Product Change Notification

PCN-PCC-8042-2022

| Business Unit | Product Line Code | Type of Change | Action | Date of Issue |
|----------------------|-------------------|-----------------------------|-------------------------------|---------------|
| PCC - PCB Connectors | AAC | Product Change Notification | Notify Distributors and Field | 7/18/2022 |

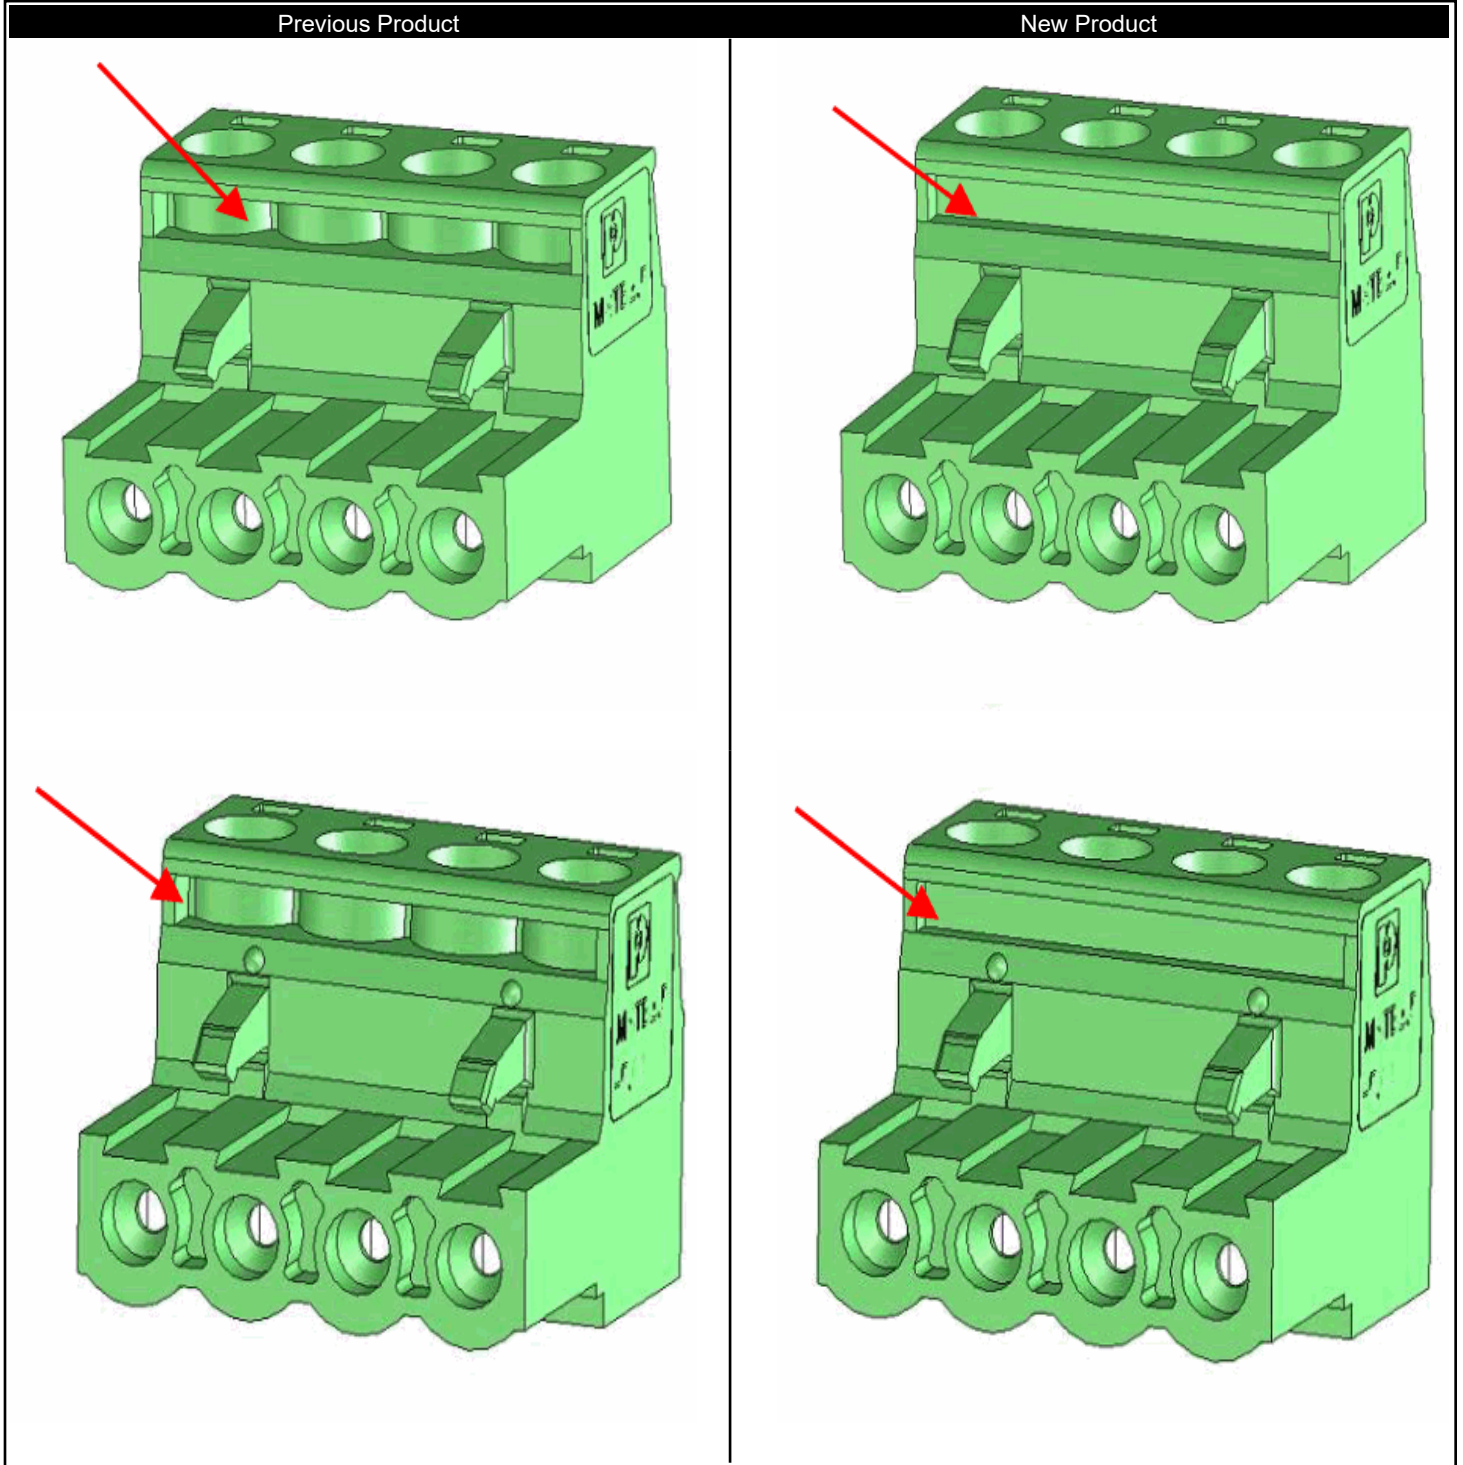
| Description for Product Change Notification |
|---|
| With the construction of new injection molding tools, the design of the material displacement of the MSTB 2,5/ connectors without flange system with 2-position through 10-position will be adapted to match that of the high-position connectors and those with flange system. A visual comparison of old/new is provided below in this document. The external dimensions, technical data, and approvals remain unchanged. The existing tools will continue to produce the old design. This will gradually be replaced with the new contour over the coming years. |
